6575A-07A

S E R V I C E N O T E

6575A DC POWER SUPPLY MANUALLY CONTROLLED

**Serial Numbers: US36340097/US36340297 & MY41000101/MY41000216 &
SG41000101/ SG41000134**

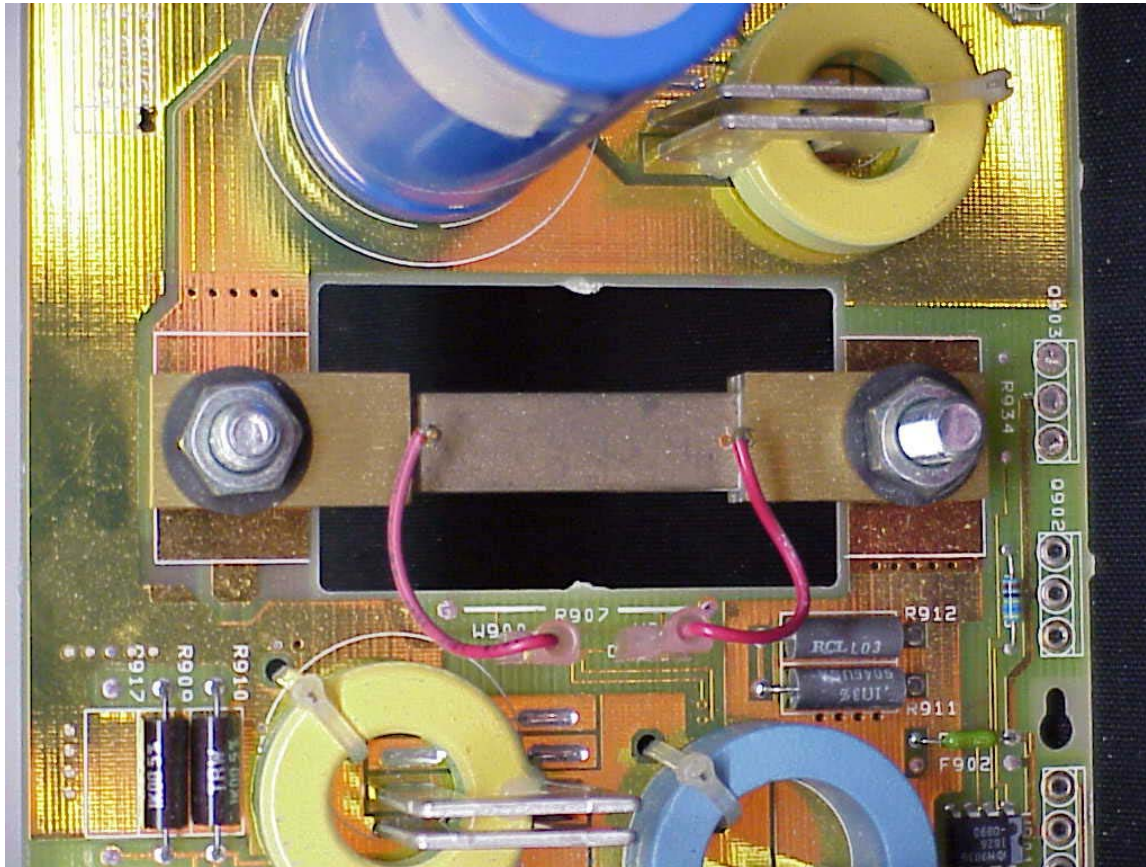
The Current Shunt (Circuit Reference “R907”) may have intermittent sense wires, which may cause Instability of Current regulation, Current read back and current programming.

When the push-on connectors become intermittent the output current will become unstable. Loose push-on connectors can cause the output current to change dramatically. The current can change from any set current, and may go to the maximum rated output current of the instrument.

This picture shows how the Shunt R907 is connected using the term-crimp connectors.

The Shunt R907 is connected to "W900" & "W901"

Cut the terminal-crimp connectors off of both wires and discard the connectors. Make this cut as close to the terminal-crimp connector as possible. The required strip length should be 5mm. This strip length will be used to prevent the wire length being too long and shorting to the instrument chassis. If replacement of this wire is required any color (22 AWG, 300V 105C) wire type can be used.

This modification can be done from the top of the board. Carefully strip and solder the wires, and avoid burning the wire insulation and the printed circuit board.

The wires should be connected as shown below. There are two holes marked R907 that should be used. Do not cross the wires when making this modification. See picture below for details. This picture shows the required modification.
